SUBJECT: **DEMONSTRATION / DELIVERY HOLD - Customer Satisfaction Program 12B36**
Supplement #2

Certain 2011-2012 Model Year Explorer, Taurus, Flex, MKS, and MKT Vehicles
PCM Reprogram - Cooling Fan Strategy

New! REASON FOR THIS SUPPLEMENT

FIGURE 1

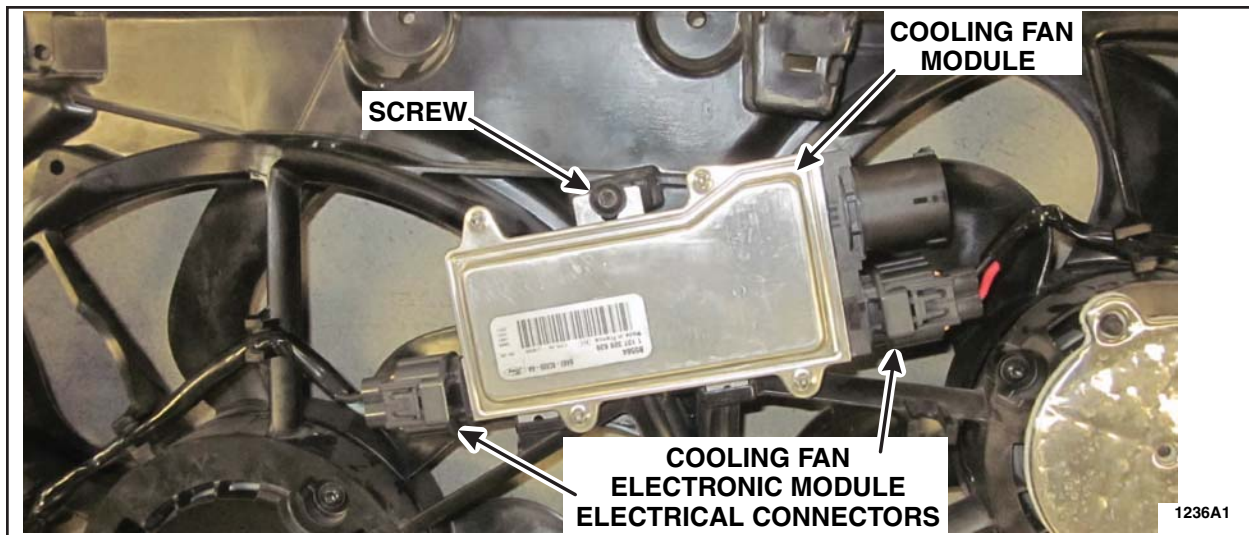
2. Disconnect the cooling fan electronic module electrical connectors. See Figure 1.

3. Remove the screw and detach the cooling fan electronic module from the cooling fan. See Figure 1.
4. Install the cooling fan electronic module by inserting both bottom tabs into the *new* cooling fan assembly shroud pockets and install the screw.
 - Tighten the screw to 7 Nm (60 lb-in).
5. Connect the cooling fan electronic module electrical connectors.
